UNITED STATES PATENT AND TRADEMARK OFFICE

APPLICATION NO.	FILING DATE	FIRST NAMED INVENTOR	ATTORNEY DOCKET NO.	CONFIRMATION NO.
10/730,894	12/10/2003	Ernesto Frassinelli	22106-00050-US	5198
30678	7590	09/29/2005	EXAMINER	
CONNOLLY BOVE LODGE & HUTZ LLP SUITE 800 1990 M STREET NW WASHINGTON, DC 20036-3425			WELCH, GARY L	
			ART UNIT	PAPER NUMBER
			3765

Office Action Summary	Application No.	Applicant(s)	
	10/730,894	FRASSINELLI, ERNESTO	
	Examiner	Art Unit	
	Gary L. Welch	3765

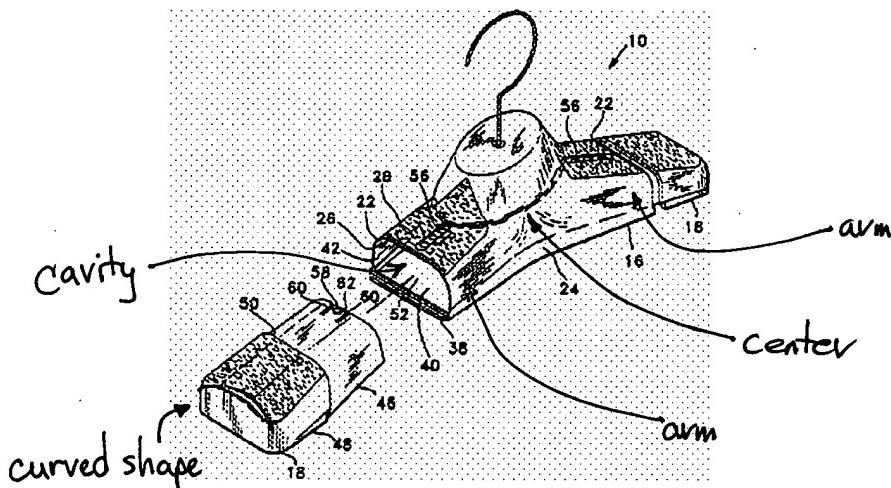
3. Claims 1-6 are rejected under 35 U.S.C. 102(b) as being anticipated by Long et al. (U.S. 5,718,358).

Long et al. discloses an adjustable clothes hanger 10 having upper hanging means 20, two symmetrical side arms 16 extending away from the center point of the hanger (see figure below) and moveable means 18 for supporting a garment. The moveable supporting means 18 are fixed integrally with sliding elements (56, 58) in cavities provided inside the arms so as to permit width adjustment of the moveable means 18.

With regard to claim 2, the moveable means of support 18 are superimposed on the arms 16 and are connected to projections of the sliding elements. The projections 58 protrude from longitudinal apertures 56 provided in the upper part of the arms 16.

With regard to claim 3, the arms 16 slant downward and the moveable support 18 has a curved shape.

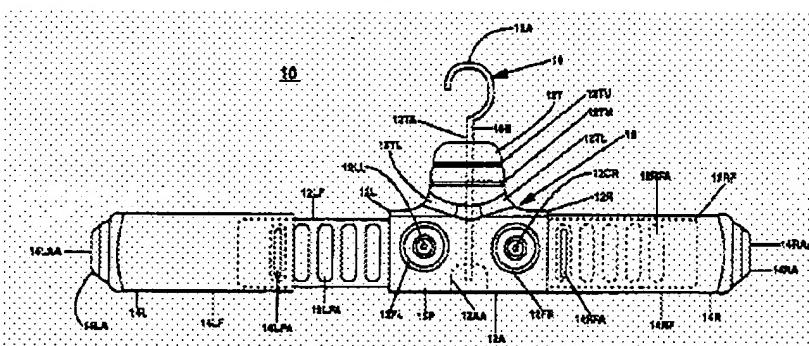
4. Claims 1, 2 and 4-7 are rejected under 35 U.S.C. 102(b) as being anticipated by Koons (U.S. 5,941,429).

Koons discloses an adjustable clothes hanger having upper hanging means 16, two symmetrical side arms (12LF, 12RF) extending away from the center point of the hanger (see figure below) and moveable means (14L, 14R) for supporting a garment. The moveable supporting means (14L, 14R) are fixed integrally with sliding elements (14LFA, 14RFA) in cavities provided inside the arms so as to permit width adjustment of the moveable means (see figure below).

With regard to claim 2, the moveable means of support (14L, 14R) are superimposed on the arms and are connected to projections of the sliding elements that protrude from longitudinal apertures provided in the upper part of the arms (12LF, 12RF).

With regard to claim 4, a protruding edge of the projections is positioned into corresponding seats provided in the lower part of the means of support.

With regard to claim 5, the sliding elements are provided with at least one tooth in forced contact with a wall of the cavities in which notches are provided and designed to engage the tooth so as to define a number of stop positions.

With regard to claim 6, the upper hanging means 16 is a hook.

With regard to claim 7, the arms (12LF, 12RF) extend horizontally along the same axis. The moveable support means (14L, 14R) are positioned below the arms and are connected to sliding elements via longitudinal apertures provided in the lower walls of the cavities.

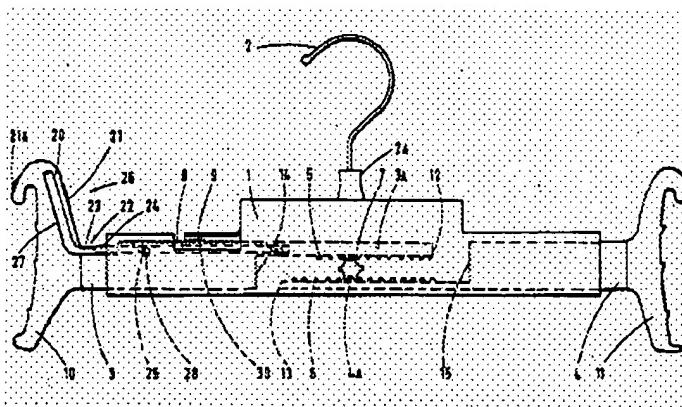
5. Claims 1, 6, 7 and 8 are rejected under 35 U.S.C. 102(b) as being anticipated by Kollegen (German Patent DE 200 08 718).

Kollegen discloses an adjustable clothes hanger 1 having upper hanging means 3, two symmetrical side arms (16, 17) extending away from the center point of the hanger (see figure below) and moveable means (4, 5) for supporting a garment. The moveable supporting means (4, 5) are fixed integrally with sliding elements (6, 7, 11 and 12) in cavities provided inside the arms (16, 17) so as to permit width adjustment of the moveable means.

With regard to claim 6, the upper hanging means 3 is a hook.

With regard to claim 7, the side arms (16, 17) extend horizontally along the same axis. The moveable means of support are positioned below the arms and are connected to sliding elements via longitudinal apertures provided in the lower walls of the cavities.

With regard to claim 8, the moveable means of support (4, 5) are provided with clips (9, 10) for gripping the garment.

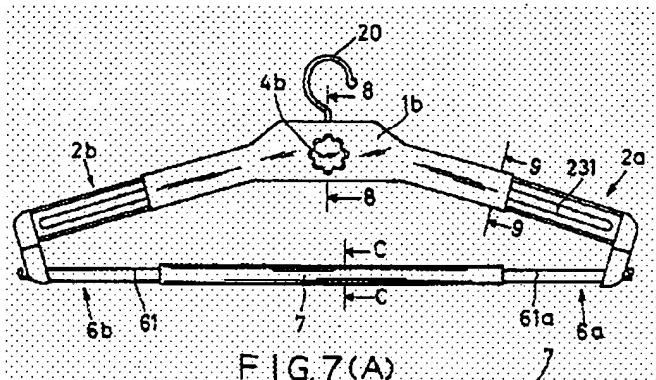
6. Claims 1, 5-7, 8 and 9 are rejected under 35 U.S.C. 102(b) as being anticipated by Hunt (U.S. 5,044,535).

Hunt discloses an adjustable clothes hanger having upper hanging means 2, two symmetrical side arms (see figure below) extending away from the center point of the hanger (see figure below) and moveable means (3, 4) for supporting a garment. The moveable supporting means (3, 4) are fixed integrally with sliding elements in cavities provided inside the arms so as to permit width adjustment of the moveable means.

With regard to claim 5, the sliding elements are provided with at least one tooth in forced contact with a wall of the cavities in which notches are provided and designed to engage the tooth to define a number of stop positions.

With regard to claim 6, the upper hanging means 2 is a hook.

With regard to claim 7, the side arms extend horizontally along the same axis. The moveable means of support are positioned below the arms and are connected to sliding elements via longitudinal apertures provided in the lower walls of the cavities.

With regard to claim 8, clips (10, 11) are provided for gripping a garment.

With regard to claim 9, sliding elements are provided with at least one tooth in forced contact with a wall of the cavities in which notches are provided and designed to engage the tooth to define a number of stop positions.
